Planning Commission Agenda Report

July 11, 2018
Item 6.a.

- SUBJECT:** P18-0075
- APPLICANT/
PROPERTY OWNER:** Alaina Stewart/Bringhurst LLC
- PURPOSE:** Workshop to review and receive comments on a Preliminary Review application for an amendment to the North Sycamore Specific Plan (NSSP) to allow the subdivision of an existing approximately 3.28-acre parcel into five single-family residential lots where three lots are allowed by the NSSP

- LOCATION:** 990 Sycamore Road
- GENERAL PLAN:** Low Density Residential
- SPECIFIC PLAN:** North Sycamore Specific Plan – Planned Unit Development-Agriculture

Figure 5: NSSP Approved and Proposed Multi-Use Trail Alignments

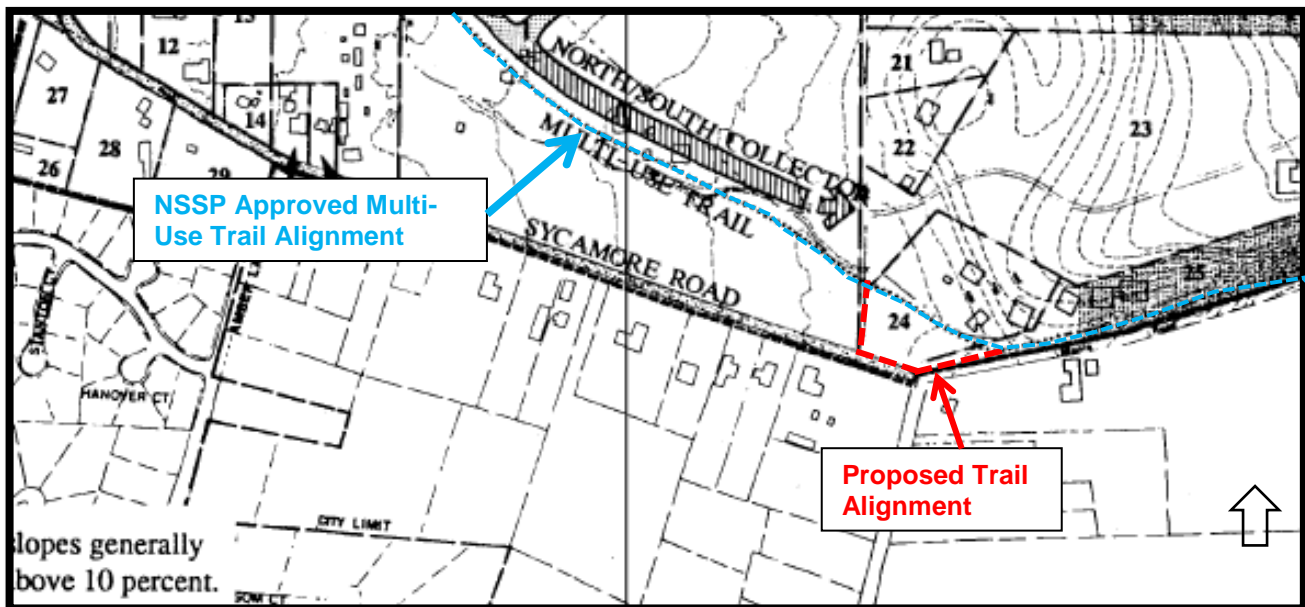
Trail Alignment and Design: The NSSP indicates a multi-use trail extending from the east-west collector along the alignment of Sycamore Creek to Minnie Street (connecting to trails to the east). The NSSP does not include design standards for the creek, but Figure VI-1 in the Specific Plan (see Exhibit E) shows a conceptual design for improvements along Sycamore Creek, including a 12 wide "multi-use all weather accessway." As noted above, the applicant proposes a realigned, 4-foot wide trail. It is staff's recommendation that the proposed trail be modified to match the existing trail that it would be connected to in width and material.

The proposed realignment was previously considered and generally accepted by the Trails Ad Hoc Committee; a similar alignment was also approved as part of PUD-97-21. Staff does not see significant issues with the proposed relocation, which would continue to provide a logical connection between the existing trail terminus and Sycamore Road (and points east), could have fewer environmental impacts to the creek, and reduce potential conflicts between trail users and private property owners. Design consideration would need to be given if there is a driveway access on to Dale Way, to avoid conflicts between trail users and vehicles. Since considerable time has elapsed since this item was taken to the Trails Ad Hoc Committee and Parks and Recreation Commission, staff would recommend that the proposed alignment be considered by both bodies, as part of the PUD plan review.

Figure 6: Proposed Layout

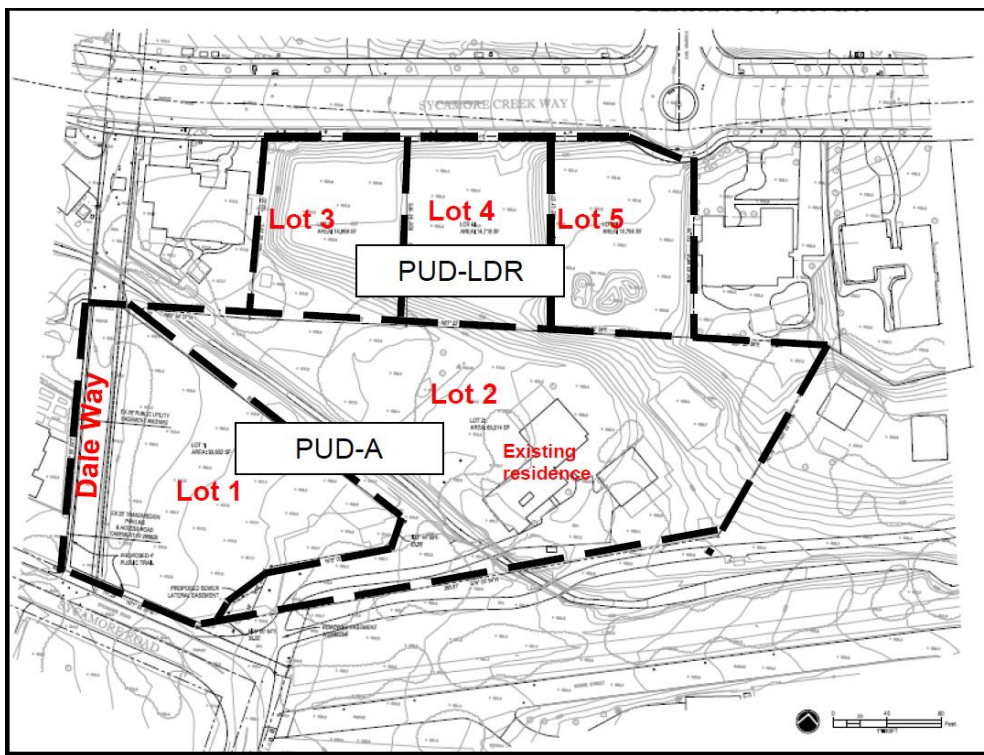
As shown in Table 3, the proposed PUD-LDR lots would range from 14,718 square feet to 14,899 square feet. Required minimum parcel size for the NSSP PUD-LDR designation is either 12,000 square feet or 15,000 square feet. The larger 15,000 square feet lot size is required by the Specific Plan for parcels located “south of the east-west collector” and as shown in the NSSP Land Use Diagram, included as Exhibit C. Note that the ultimate circulation of the NSSP differs from that envisioned in the circulation plan, with Sycamore Creek Way following somewhat of a hybrid between the alignment of the “east-west” collector and a second “north-south” connector, meaning that an interpretation of the NSSP with regard to minimum lot size for this parcel must be made.

In staff’s view, it is reasonable to apply the 15,000 square foot minimum lot requirement, which is closer to the larger parcel size required for the current PUD-A land use designation; is more consistent with the character of the majority of properties adjacent to and across Sycamore Creek Way from the Bringhurst property³; and appears consistent with the intent and mapping of the NSSP. While the deviation from the standard is not substantial, staff would recommend that proposed lot lines be adjusted so that all of the lots are at least 15,000 square feet in size.

For the PUD-A lots (Lots 1 and 2), per the NSSP, a minimum one-acre lot size is required. As proposed, Lot 1 would be less than one acre in size (33,602 square feet, or 0.77 acres) and Lot 2 would be 65,074 square feet, just under 1.5 acres in size. In the previous preliminary application, staff had recommended that the lot lines be configured to include the entire creek on one or other of the two properties so as to clearly assign responsibility for ownership and maintenance of the creek. As proposed, the entire creek would be located on Lot 2, the parcel with the existing residence. Staff believes there is merit to retaining clear ownership of the creek, and thus potentially to provide some flexibility (consistent with the intent of the PUD process) in the lot configuration; however, the Planning Commission should consider this in light of the entire proposal. Since the NSSP requires a minimum one-acre lot size, it would also be necessary to amend the Specific Plan to allow for this deviation.

It should also be noted that the Engineering Department has identified the need to dedicate a minimum 60' wide public access easement and storm drain easement centered on the creek centerline, matching the existing 60-foot wide easement in the Bridle Creek development. This may constrain the placement of homes and/or accessory buildings in the ultimate development plan. Irrespective of the easement, the property owner would remain responsible for maintenance of the creek.

The conceptual aerial site plan shows a detached garage for Lot 1, which would be accessed from Dale Way. If the garage faces Dale Way, staff believes it should be set back at least 25 feet from easterly edge of Dale Way to allow parking in the driveway without encroaching into Dale Way.

In evaluating the proposed maximum FARs and their compatibility with the surrounding residential developments, staff reviewed the Sycamore Heights development (PUD-LDR) and the nine PUD-A lots in the Bridle Creek development along the north side of Sycamore Road. The Sycamore Heights development limits the majority of the development to a maximum of 30% FAR; a few lots were permitted a slightly higher FAR of 33% at initial construction. Staff believes Lots 3-5 should have a maximum FAR of 30%, matching the maximum FAR for most of the lots at Sycamore Heights.

Similarly, staff believes that Lots 1-2 should have the same FARs as the Bridle Creek's PUD-A lots, which is 20% excluding up to 600 sq. ft. of garage floor area. The FAR calculation for Lot 2 should be based on the site area excluding the non-developable creek area.

Grading: As previously mentioned, the existing grades on the northern portion of the project site differ from those shown on the approved grading plan. The existing grades have three stepped pads that are higher than the adjacent Sycamore Creek Way, especially for Lot 3, where the grades are almost to the first floor ceiling plate of the home located at 941 Sycamore Creek Way. When the application returns for a formal review, a grading plan needs to be included as part of the submittal. Staff would recommend that re-grading of the site be required, to lower the elevation of the pad closest to 941 Sycamore Way by several feet, and avoid a future home “looming” over the existing residence.
